**Addendum Number 2 to the Contract Documents for the
Invitation to Bid for P21067; 10th and N Sewer Upgrade – Phase 2**

P21067
10th and N Sewer Upgrade – Phase 2

STANDARD MANHOLE
FRAME AND COVER ADJUSTMENT
FOR PAVED TRAVELLED WAY LOCATIONS

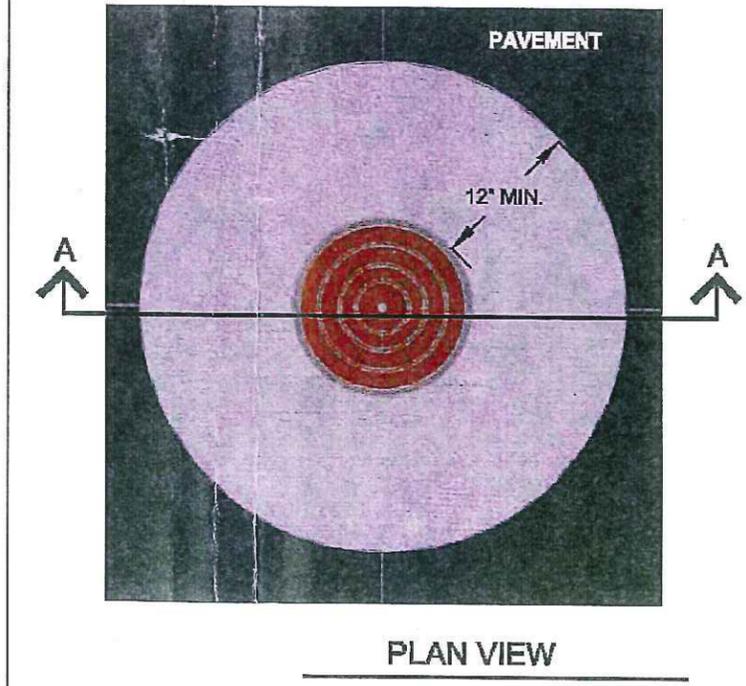
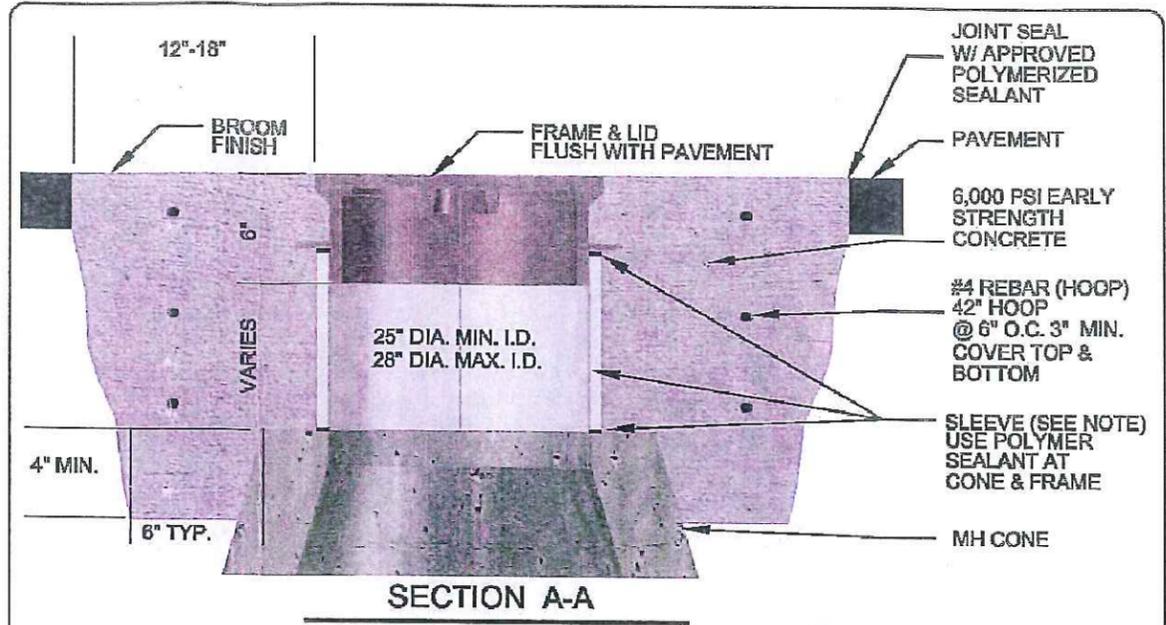
- 1.) Effective immediately the deadline for submission of questions is being extended to Friday, February 28, 2014 at 9 a.m. All questions received after the original deadline for submission of questions that were disallowed will be answered either by posting responses to the Clarifications Log or through the issuance of additional Addenda.
- 2.) Bid Item 281 Traffic-Rated Manhole Collar: Plan Sheet 4 "Standard Manhole Frame and Cover Adjustment for Paved Traveled Way Locations" is added. See Attachment 1 to this Addendum.

NOTE:
CUT ROUND HOLE IN PAVEMENT.
PLACE MANHOLE COVER AND
FRAME AT FINISH GRADE.
PRESS PVC AND FRAME INTO
MH CONE TO SEAT.
FRAME AND COVER:
INLAND FOUNDRY CO. OR EQUAL
FRAME.....NO. 802
COVER.....NO. 802-2
SLEEVE: USE APPROVED POLYMER
SEALANT MATERIAL, PREFERRED
27" PVC, HDPE, OR OTHER AS
APPROVED BY ENGINEER.
